AGENDA
Regular Hybrid Meeting
Town of Granby
Inland Wetlands and Watercourses Commission
Wednesday, August 13, 2025, at 7:00 pm
Town Hall Meeting Room

MEETING MINUTES
Town of Granby
Inland Wetlands and Watercourses Commission
Wednesday, July 9, 2025, at 7:00 pm

- a. **8 East Granby Road – C. Peeler c/o AutoZone, Inc. – Permit application to demolish existing structures and construct a 6,796 sq. ft. commercial building and other associated site work within a regulated area.**

This letter is being submitted by Kimley-Horn & Associates, Inc. on behalf of AutoZone, Inc. ("Applicant") in response to the department review letters listed below:

SHEET 1 OF 1

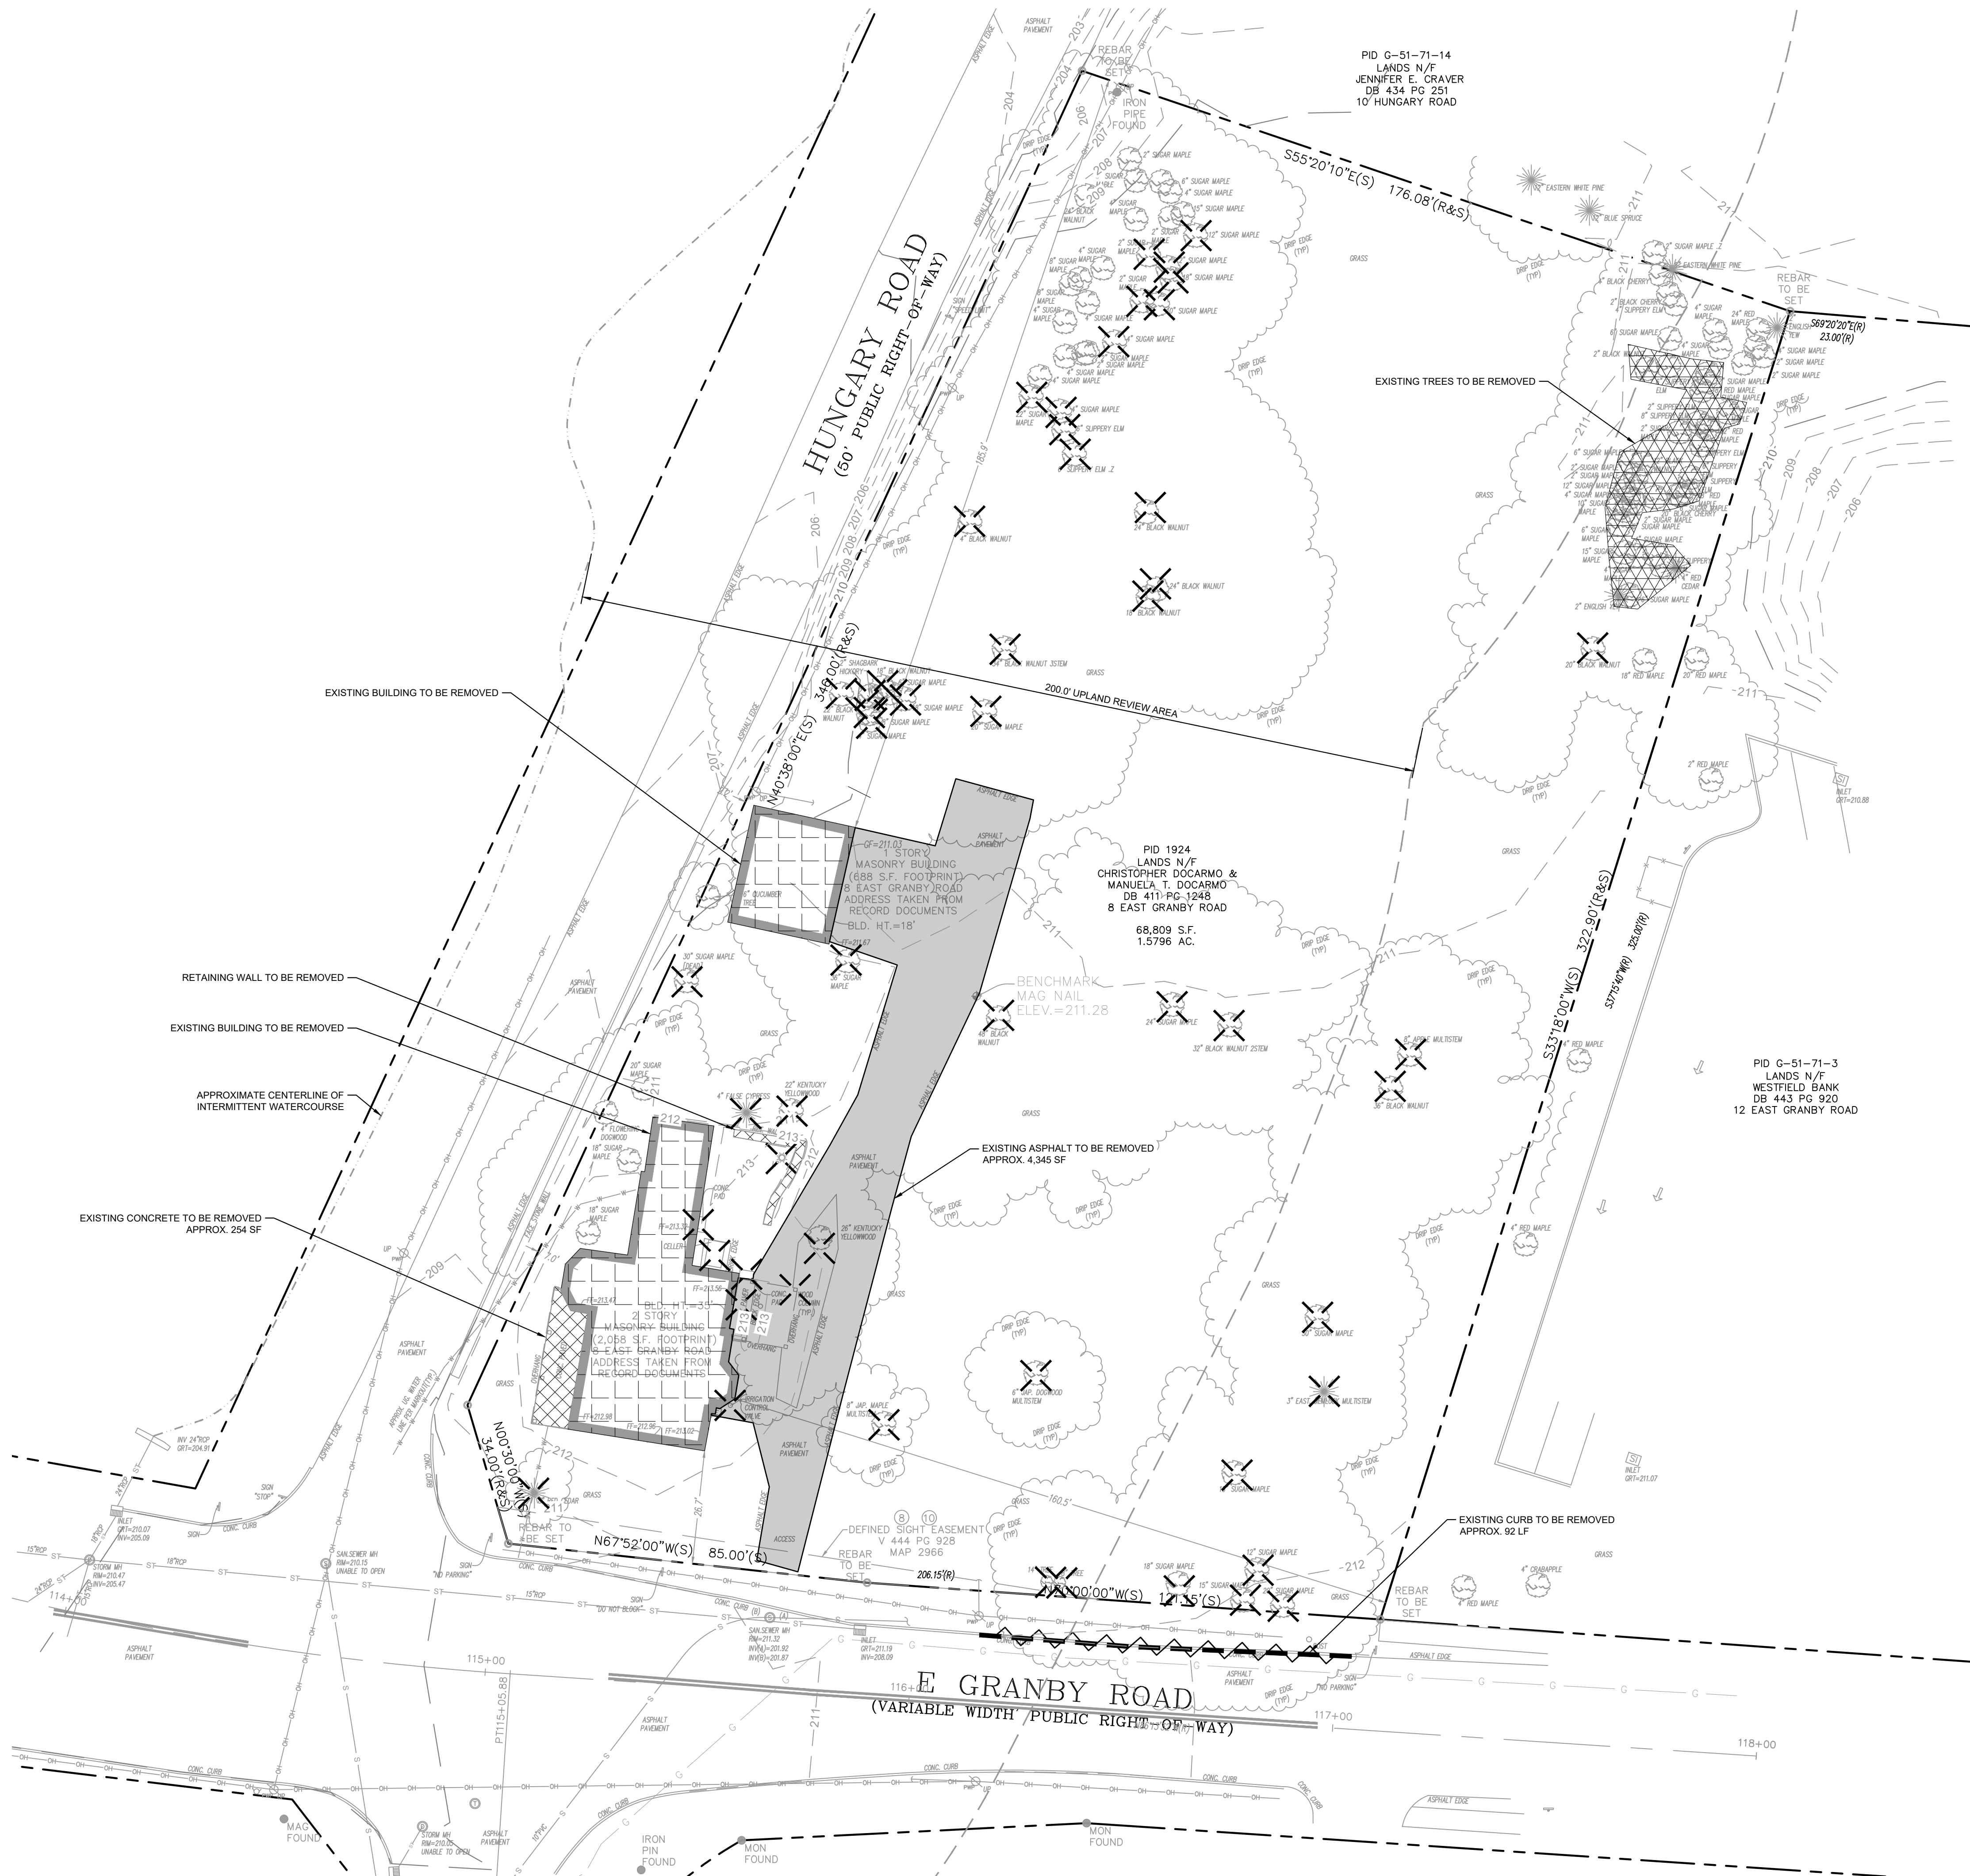
1. Show and label existing sidewalk.

Response: The existing sidewalk is shown, and a label has been added on the Survey Sheet.

SHEET NUMBER
C-3.0

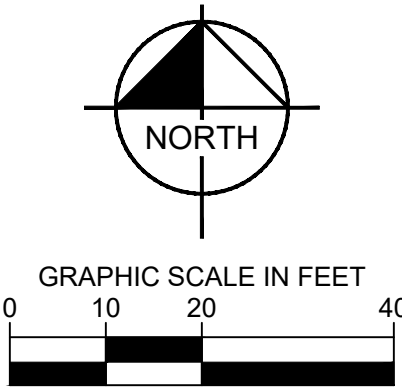
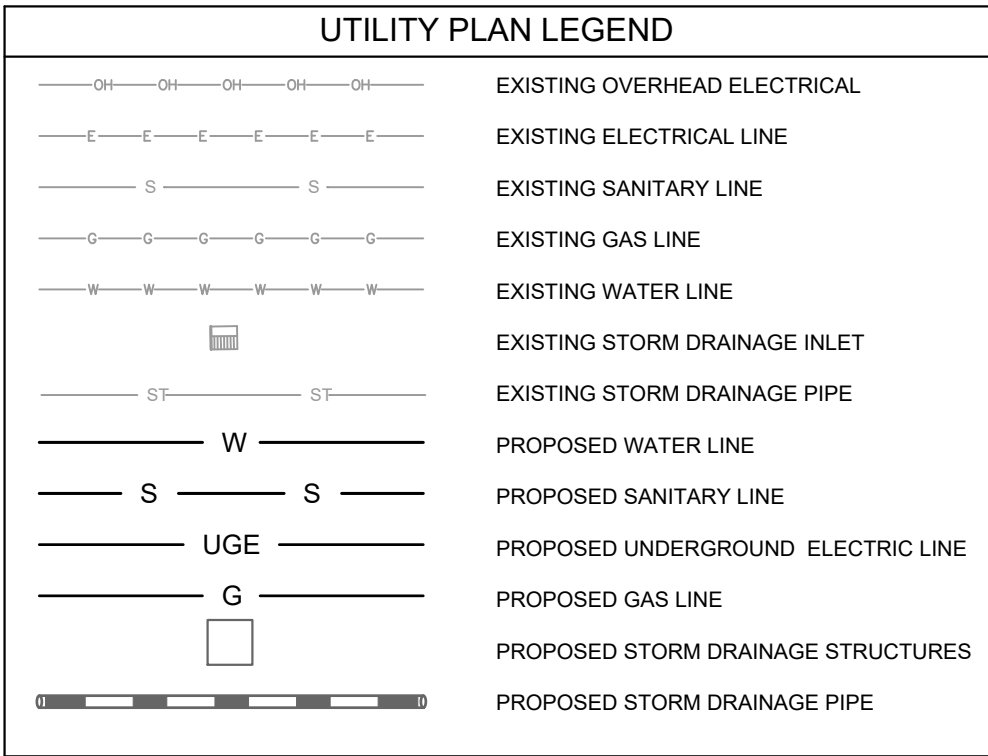
2. Show test hole information on this sheet.

3. Add the test hole pit data to the report and on sheet C-3.0. Test pits and soil data reporting to comply with the Connecticut Stormwater Quality Manual, March 30, 2024, Chapter 10, Test pits and Borings, pages 178 and 179.

Response: Sheet C-3.0 has been revised to include the test pit information (testing elevation and infiltration rate).

Response: Test pit data is included in the SWMP on page 14 and the full geotechnical report is provided in Appendix A.

Per the CT Stormwater Quality Manual, if the infiltration rate exceeds 8.3 in/hr, then 100% of the stormwater quality volume requirement must be treated using a different stormwater management practice before entering the infiltration basin. Therefore, the project stormwater management plan has been revised to include a bioretention basin before the

infiltration basin to treat the required water quality volume. The provided site plans and SWMP have been revised to include the bioretention location and details.
